**North Group-Redwood Chapter-Sierra Club
Felice Pace, Water Chair**

September 23, 2021

SUBJECT: Comments of the North Group Water Chair and a Scott Valley landowner on the Draft Scott River Basin Groundwater Sustainability Plan (GSP) released for comment August 11, 2021.

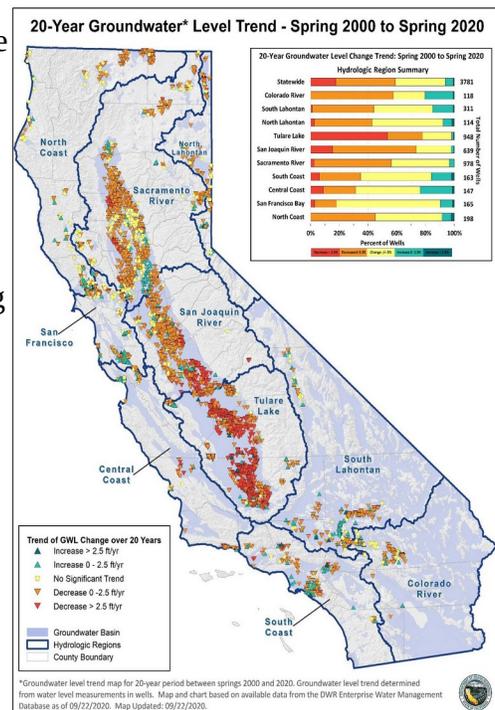
One cannot solve a problem if one refuses to recognize that the problem exists. The Draft GSP denies the reality that groundwater levels and groundwater storage have been declining in the Scott Valley for two decades. This can clearly be seen in the DWR SGMA Data Viewer, and in DWR's Spring 2020 Update, including the map to the right which shows "groundwater level trend" from 2000 until 2020. Like most of the state, DWR's Scott Valley groundwater monitoring wells shows the groundwater level decreased year-to-year up to 2.5 feet since 2000. More recent trends, in line with climate expectations, are much more dire.

The GSA and the Scott Groundwater Advisory Committee need to get out of denial. They need to admit that groundwater extraction has already produced unacceptable results and they need to give the public a plan that will restore the beneficial uses of water which groundwater extraction in the Scott River Basin has damaged and threatens to destroy.
